Amendment: Departure headings amended.

CIRCLING AUTHORIZATION AREA

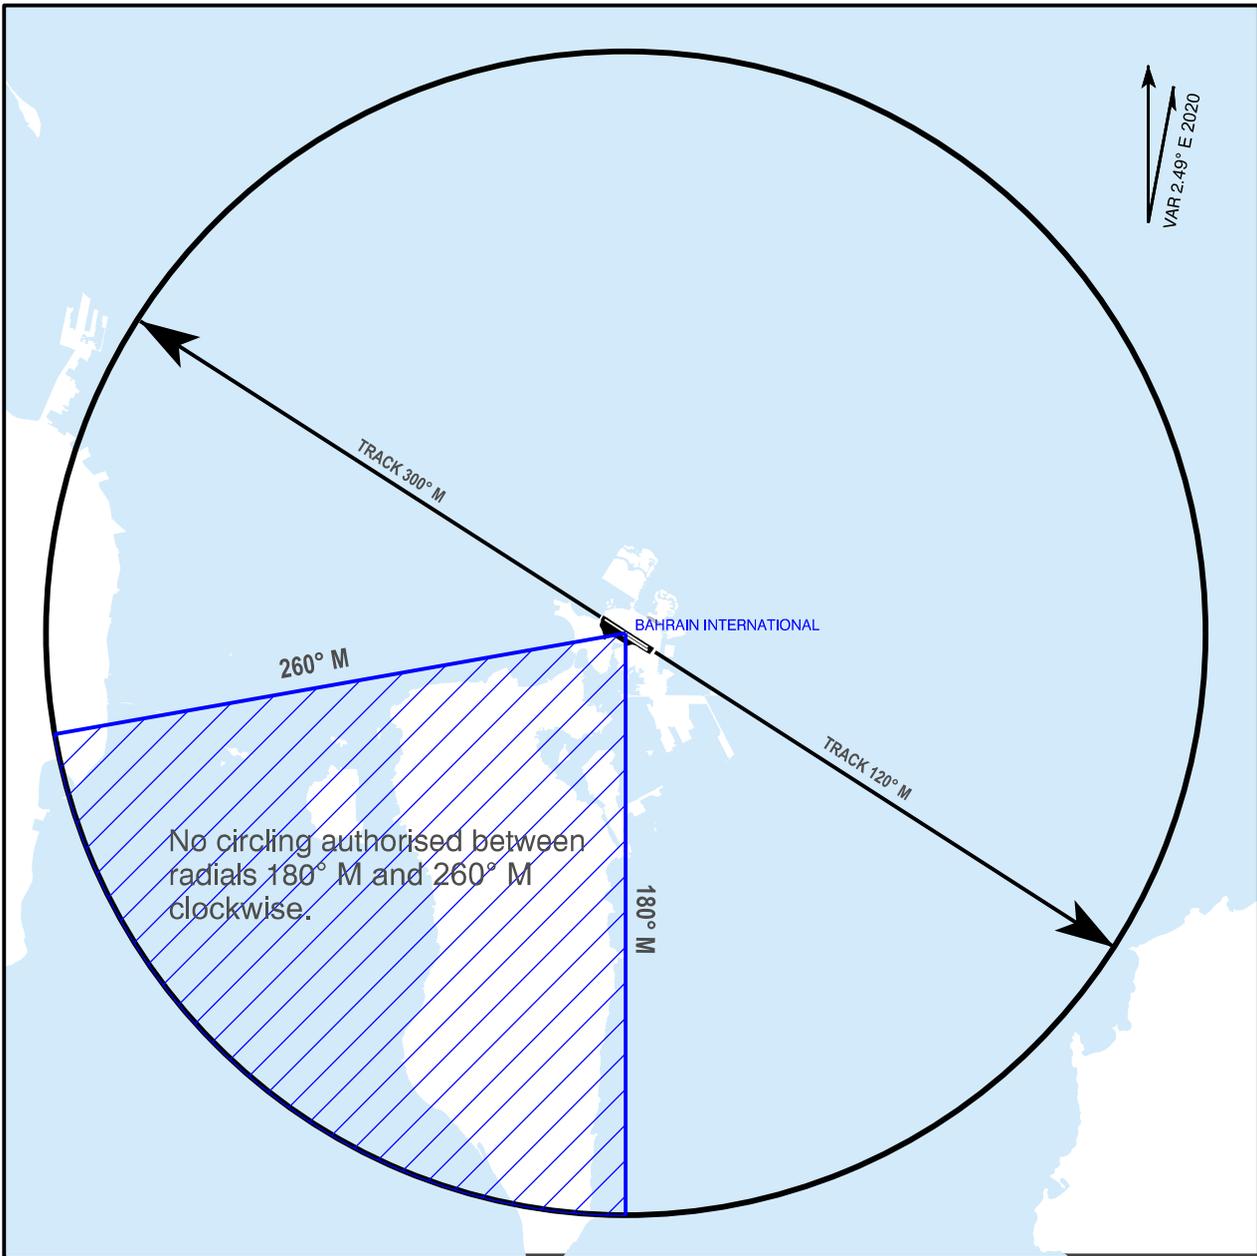
- APPLICABLE TO RWY 12L/30R DEPARTURE.**
- 1) RWY 30R Expect right turn heading 345°M or heading 300°M.
 - 2) RWY 12L Expect left turn heading 075° M or heading 120°M.
 - 3) Departure Frequency 119.100 MHZ.
